STAFF REPORT CONCERNING APPLICATION FOR A CERTIFICATE OF APPROPRIATENESS

Date: November 14, 2018 **Application Number:** 2018-1107

Property Location: 916 Riverside Drive

APPLICATION ITEMS: "Relocate existing side entry on stoop and install wood frame window at old door location."

Figure 1 - 916 Riverside, from the driveway.

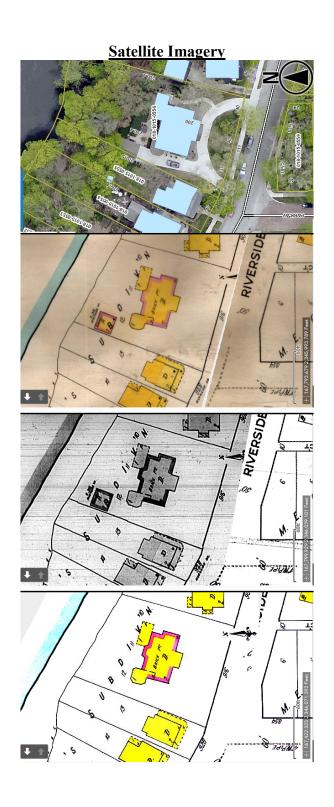
STAFF RECOMMENDATION: Staff recommends approval, as this project is in keeping with the Standards and Guidelines for the Riverside Drive Local Historic District.
